West Parcel Solar Project

Project Final Tiered EIR

Volume 3 Response to Public Comments on the Draft EIR

WEST PARCEL SOLAR PROJECT
Response to Public Comments
SCH 2002041161
Volume 3

Hillside Losses from Solar Project Traveling from Snow Creek to Amar Road

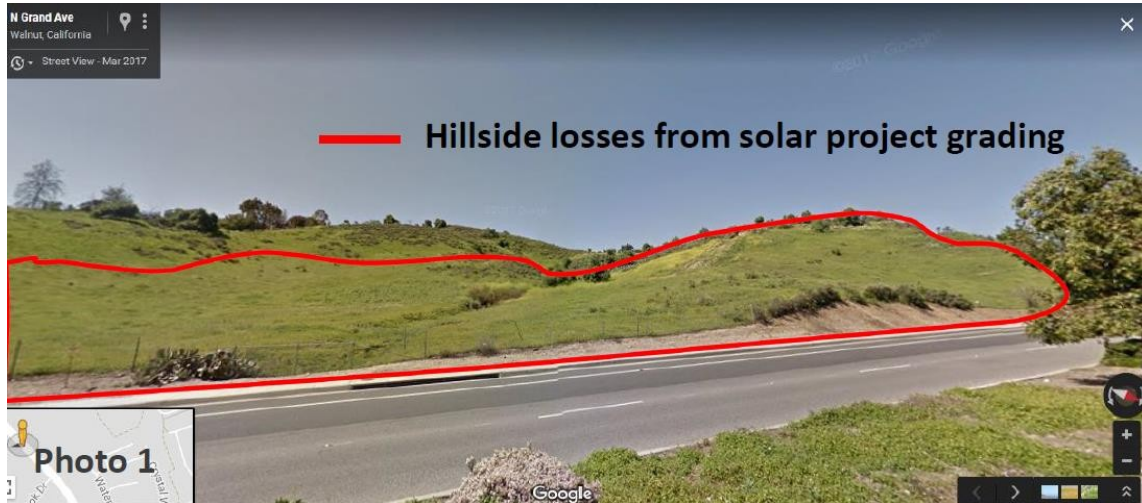
Comment 5.2.5: Motorists Traveling Grand Avenue Observe Mass Hillside Losses Inconsistent with General Plan

- 5. Motorists traveling Grand Avenue would observe loss of hillsides, which is inconsistent with the General Plan Scenic Corridor designation of the roadway. The following views of Grand Avenue (photos 1 through 3, below) traveling from south to north from Snow Creek Drive to Amar Road displays the scenic values of Grand Avenue at street level and the significant destruction of native hillsides and vegetation caused by the west parcel project.

Response 5.2.5. The photos of the project frontage (photos 1 – 3) prior to development presents an incomplete portray of the project. Generally, pre- and post-development photos are presented for a project, so the reader can determine how the project is viewed when graded and landscaped. The District has already presented pre- and post-project photos in Appendix J of the Draft EIR. The comments seem to presume that any loss of hillsides is significant and development onsite should not proceed. This is contrary to the District’s objectives and legal issues related to the project site.

Total Project Cost - West Parcel (DEIR)
Grading/Landscaping & Earth Export Savings

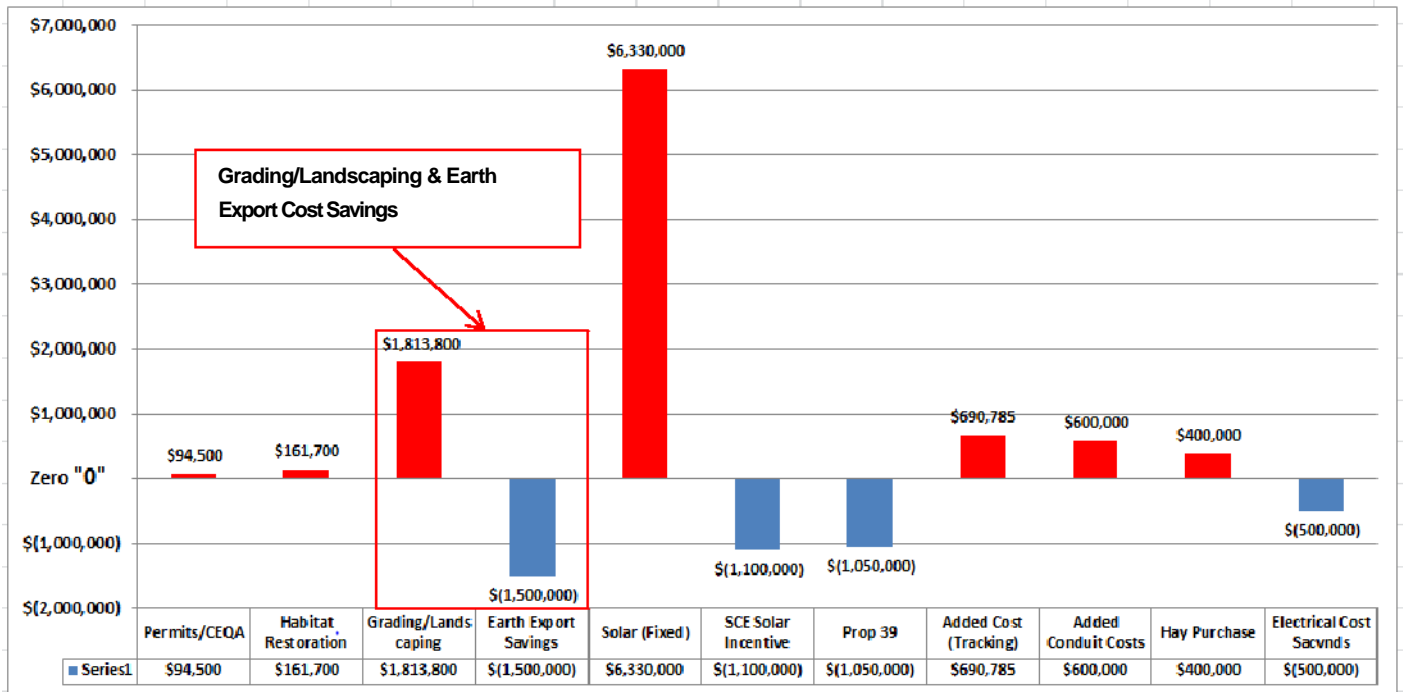
Examination of West Parcel Costs

31. The first chart shows the raw WPSP costs in the DEIR. It includes the various costs adjustments and credits applied by Mt. SAC after the construction costs are developed. The third vertical bar is the grading cost. The fourth bar is grading savings (a negative cost) if the stadium hill dirt is exported to the west parcel and not off-site.

33. These costs also do not account for possible additional remediation of landslides associated with High Landslide Potential lands identified on the LA County Engineer mapping for the City of Walnut General Plan and on the California Geological Survey CGS 88-21 Map No. 12 for this region, designating most lands at the west parcel at “close to their stability limits”.

The comments in Items 31 – 34 primarily are explanations of the assumptions used in the following table. The first table (Series 1) displays the data included in Table 6.6.1 in the Draft EIR and the second table is similar, except it combines the grading/landscaping estimate and the earth export cost saving estimate. No new information is provided by the two tables.

Total Project Costs
West Parcel (DEIR) vs. Parking Canopy Mounted Solar Pa

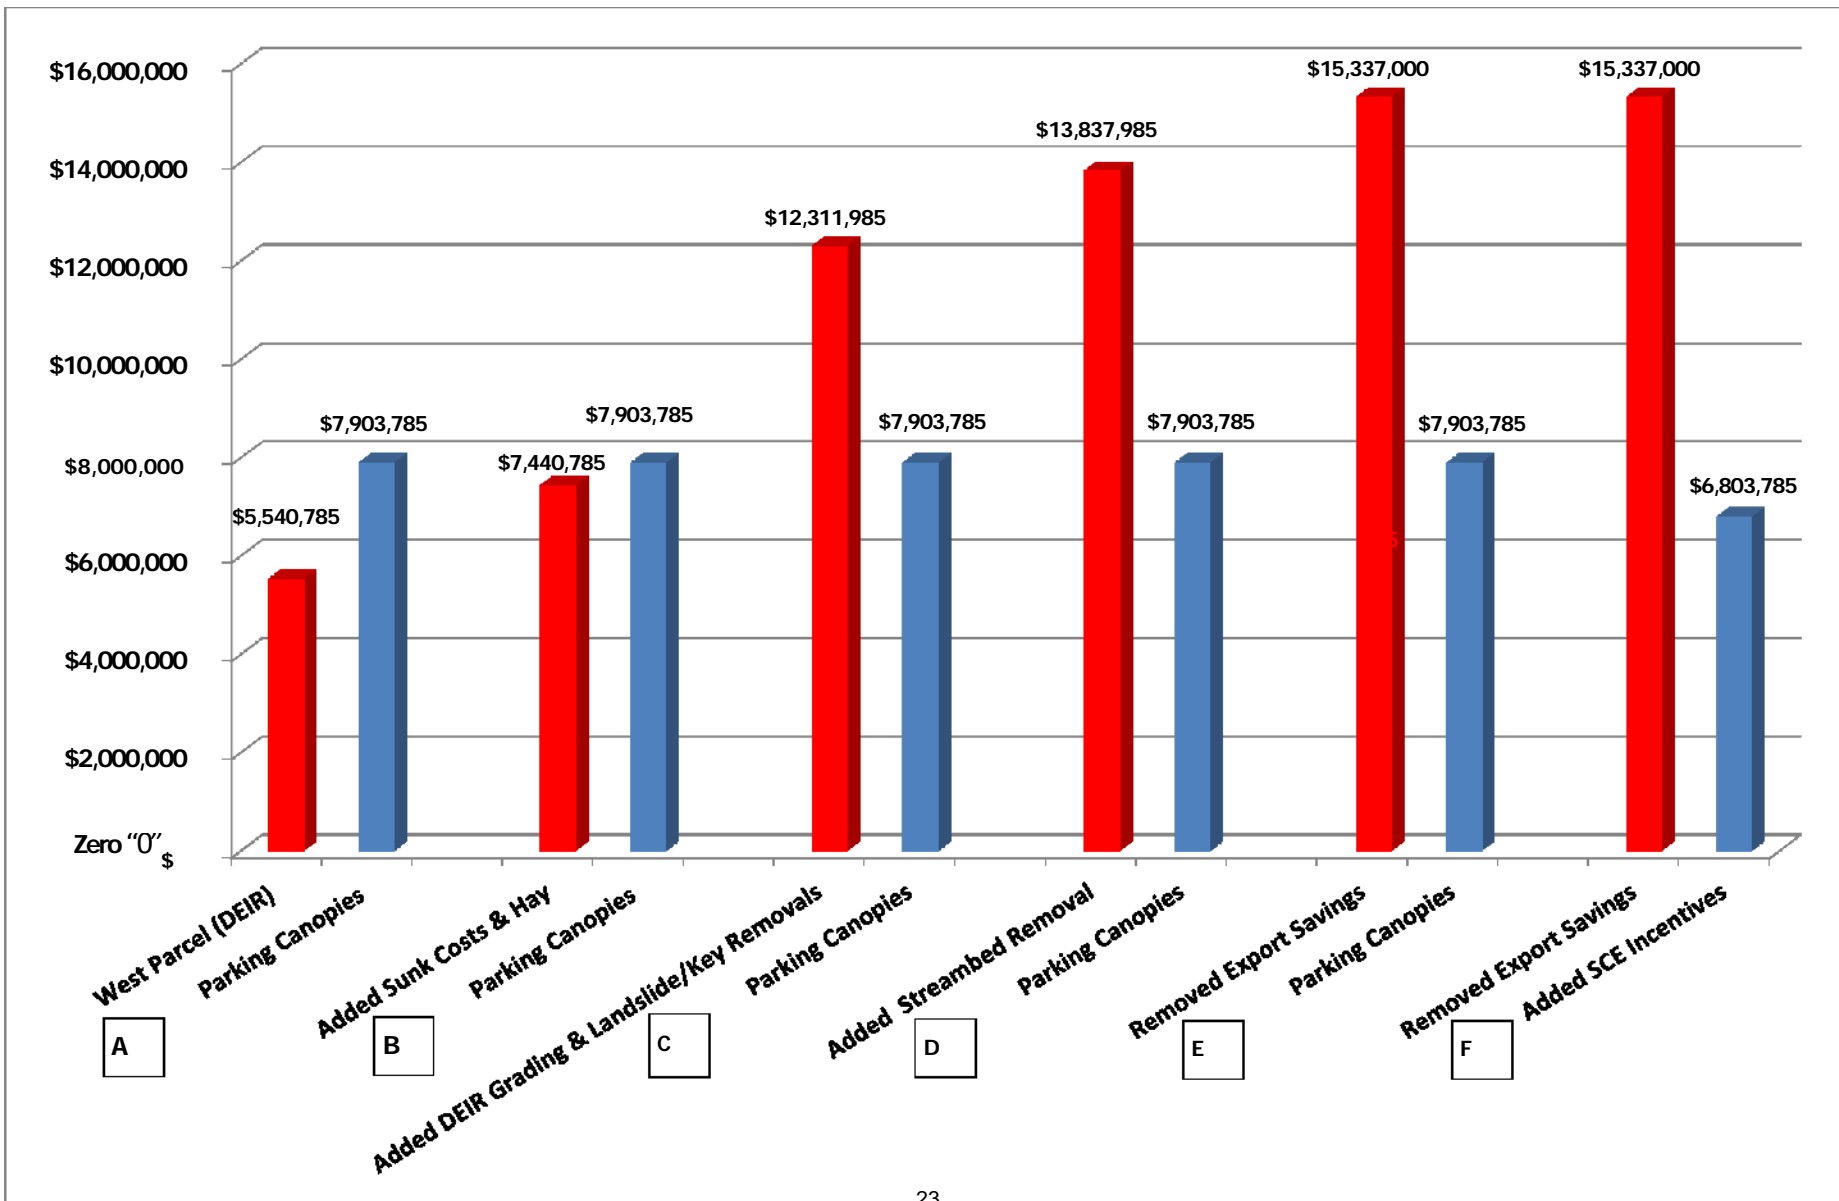
Comment 5.2.18: Total Project Costs

- 41. Within the following table, the total west parcel cost in Vertical Bars C is \$12,311,985. This cost includes the cost adjustments and credits applied by Mt. SAC, which if excluded, would yield the hard dollar construction costs of the project equal to \$13,271,300. This cost is based on grading quantities from Psomas grading plans and landslide removals characterized in the DEIR. When multiplying these quantities by unit costs of local and statewide contractor bids for similar work and quantities, it produces the \$13,271,300 value. This value compares favorably to the \$13,723,645 Total Project Budget including Site Improvements and Earthwork identified in the Mt. SAC Board of Trustees Action for Professional and Design and Consulting – added Services (contract Amendments), page 37, October 12, 2016.

42. Economic studies to assess ROI & Payback (Table 6.6.2) have been based on the west parcel project Net Cost of \$5,440, 785. Because these costs are considered unreliable as noted above, they should not be relied upon for development of ROI & Payback studies or for decision-making.

Response 5.2.18. The comment in Item 41 regarding the \$13,723,645 Total Project Budget including Site Improvements and Earthwork identified in the Mt. SAC Board of Trustees Action for Professional and Design and Consulting – added Services (contract Amendments), page 37, October 12, 2016 is noted.

However, as stated previously, construction cost is not the sole criteria used to compare the benefits of the project and a canopy mounted systems. All of UWT cost comparisons ignore the opportunity costs for future facilities that cannot be built in land devoted to a canopy solar system and do not comment on the environmental issue comparisons for project alternatives, as shown in Table 6.6.3 of the Draft EIR.
